**PLANNING COMMISSION
STAFF REPORT**

AGENDA ITEM: Planning File No. MAJ-25-0006: A sketch plan review of a townhome residential development located at 212 S 6th Ave.

LOCATION: 212 S 6th Ave/ Lot 1 Cabin Preserve Sub And In Cabin Preserve Sub Future Expansion & S1/2 Lots 13-18 Block 17 Frisco Town Sub

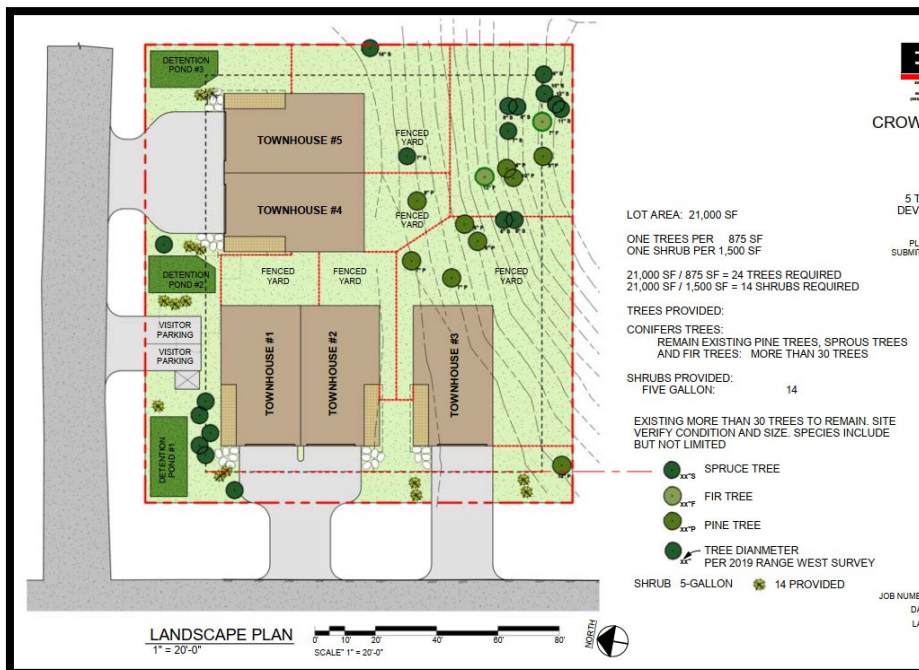
The Application shows 2,482 square feet of uncovered paved area and 565 square feet of uncovered deck area requiring 761.75 square feet of snow storage. The Application shows 1,796 square feet of snow storage.

At the time of the final review of the Major Site Plan application, the Applicant will be required to demonstrate that snow storage is provided in accordance with Town Code including the square footage, feasibility that it will not lead to snow being plowed or shoveled into the neighboring properties. Currently, it appears that snow will be deposited on adjacent properties within the development. Further clarification of the exact amount of snow storage and the location of snow storage will be needed for the Final Site Plan application.

April 2, 2020 **A13**

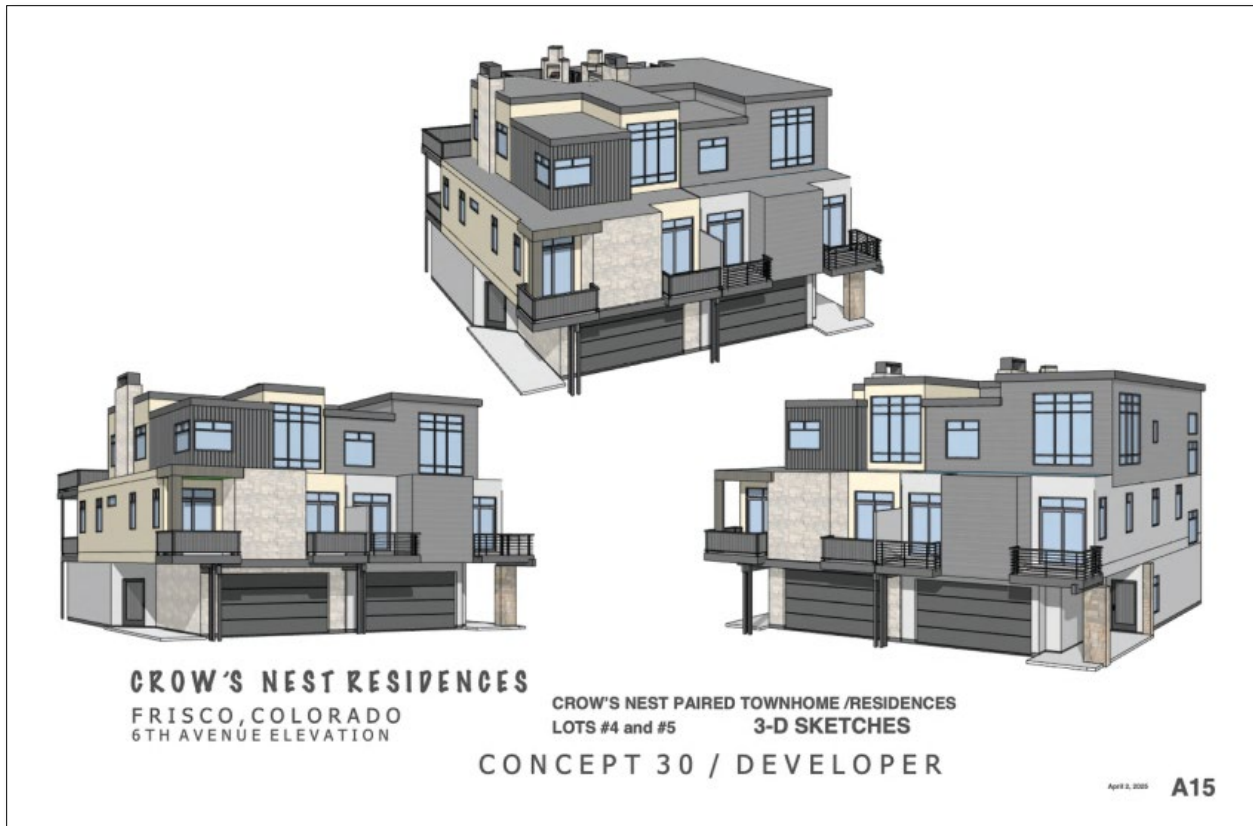
The building design does not duplicate other buildings within a 300-foot radius of the Property. Units appear to be similar, although not identical in nature, and there are similarities and symmetry between units.

The building design of the attached two-unit structures do not look like a single-household structure. Additionally, the proposed side elevations could be considered a mirror image of each other.

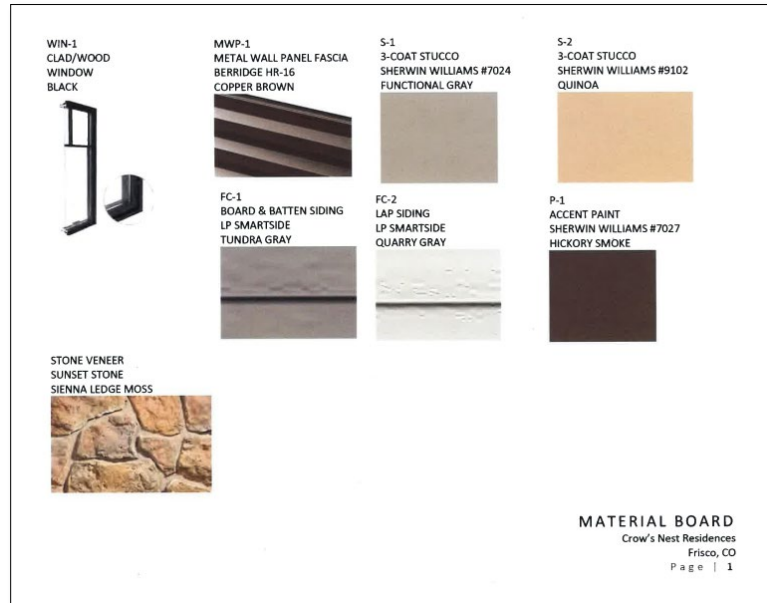
The Application includes a sample material board, and the materials are shown on the elevations and in a 3-D rendering. The Application proposes metal wall pane fascia, stucco, board & batten siding, lap siding, and a stone veneer. The stucco is only acceptable when used in combination with acceptable materials. Stucco appears to be proposed in a large quantity on the side elevations. Staff are concerned that the building materials lack sufficient variation. Staff would like input from the Planning Commission on the proposed materials and if they think the proposed stucco is adequately being used with other acceptable materials.

BULK PLANE STUDY @ EAST SIDE PROPERTY LINE

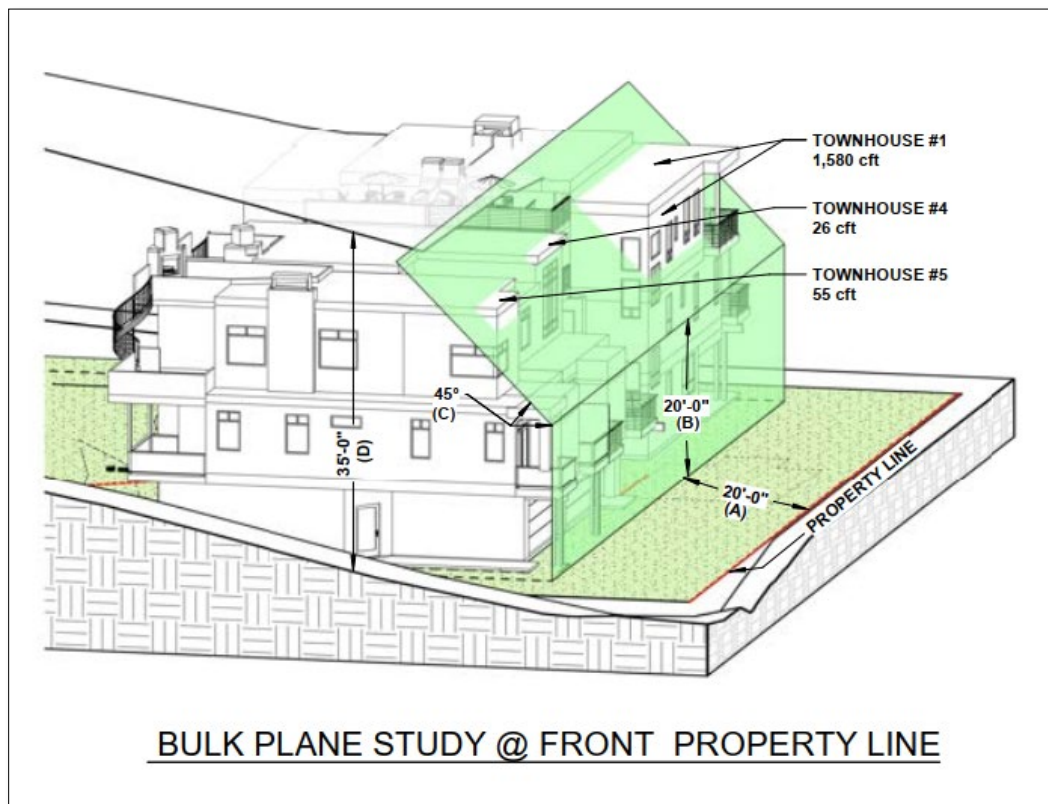
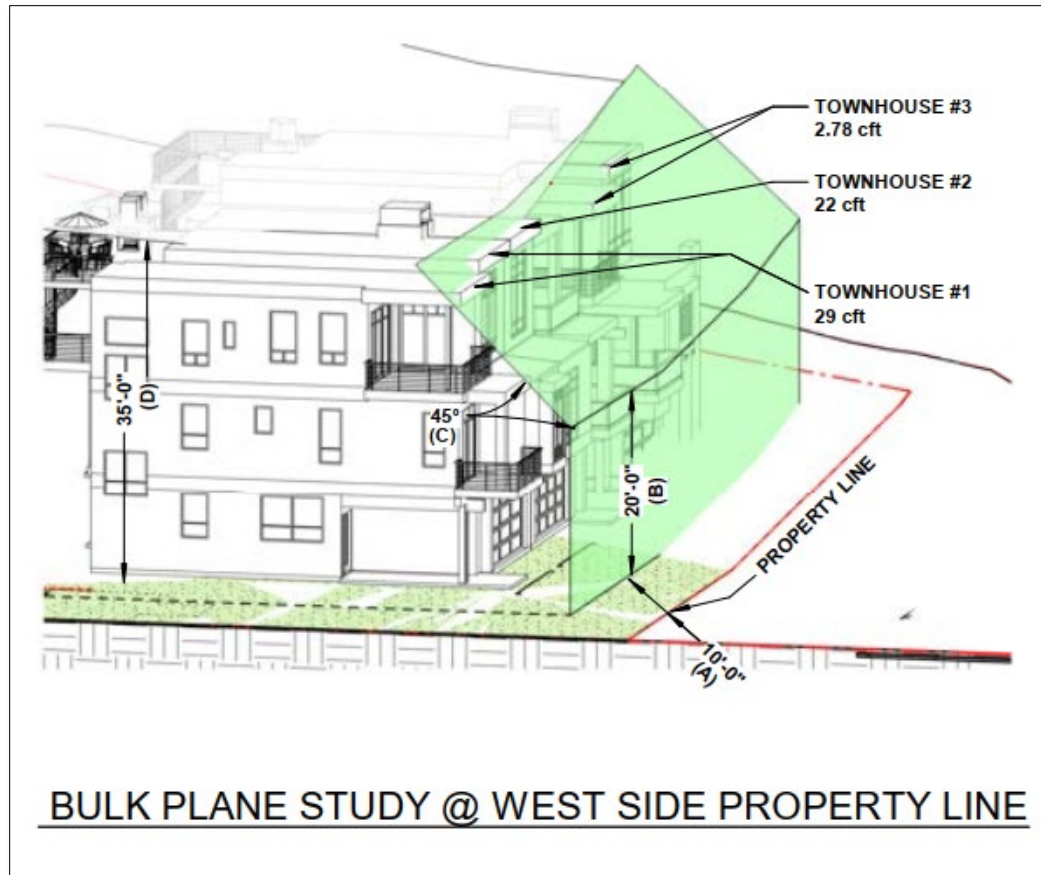
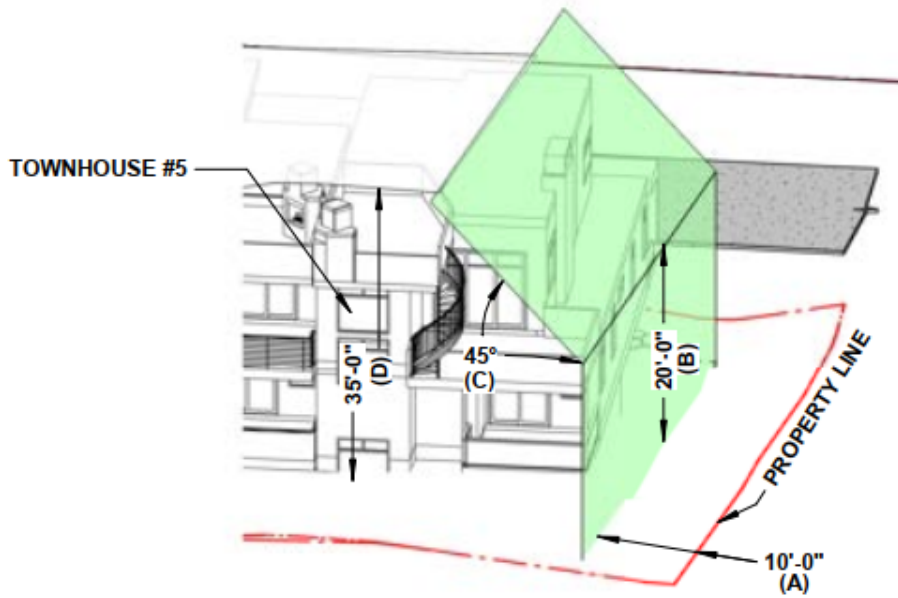
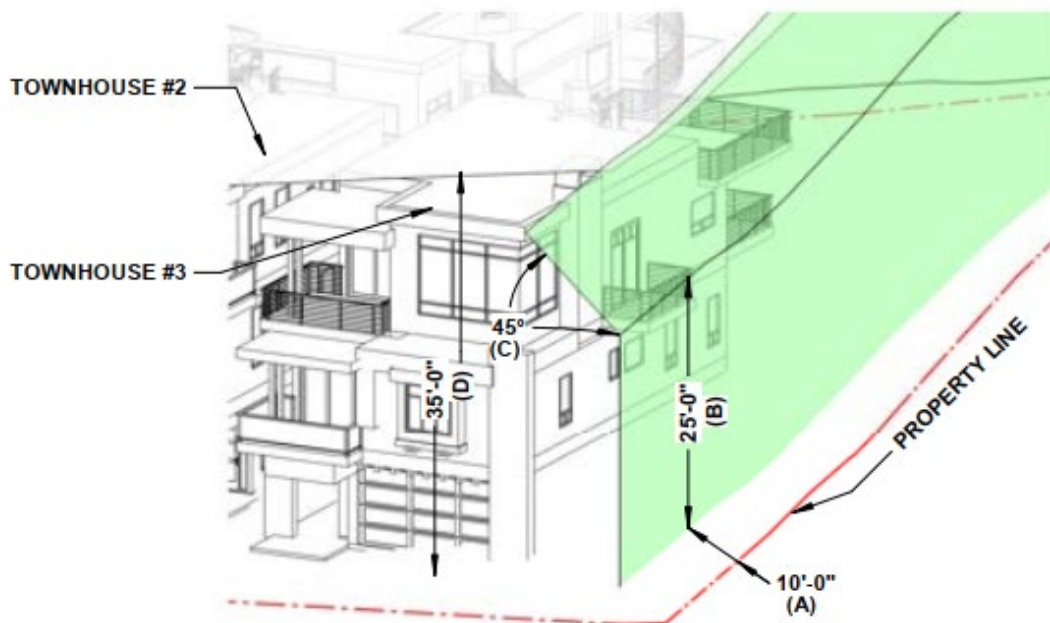
The Application materials show a total bulk plane encroachment of 1,714.78 cubic feet.

Staff does not find that the proposed bulk plane encroachments provide substantial architectural relief; some of encroachment areas appear to provide increased floor area which is not in compliance with providing substantial architectural relief. Staff requests that the Planning Commission comment on whether the proposed bulk plan encroachments provide substantial architectural relief.
